Water Resource Comments on Orleans Comprehensive Wastewater Management Plan/ DRI

April 14, 2011
6 PM
Assembly of Delegates

Six-Phased Core Sewer Plan

Conservative Assumptions and Hydrogeologic Uncertainty

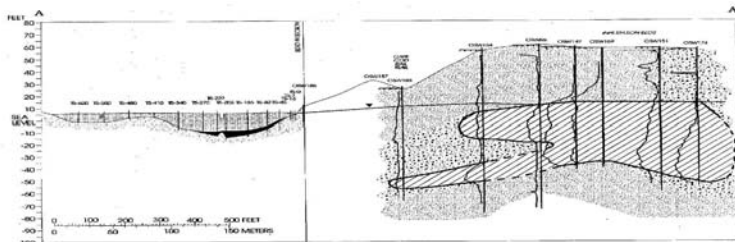
- Consultant Model conservatively indicates that 70% of effluent flow may discharge into Namskaket Creek
- USGS Studies indicate a larger percent of effluent flow passes beneath Marsh to Cape Cod Bay

Figure 16 Bay-wide trends in dissolved inorganic nitrogen (DIN) surface concentrations over the 2000-2009 period. Dashed lines indicate approximate 90% confidence intervals (CI). Both pre-break and post-break trends are statistically significant.

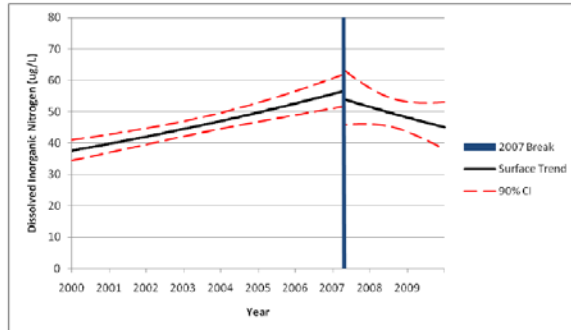
- Post 2007 Breach has improved Water Quality in some sectors of the Major embayment.
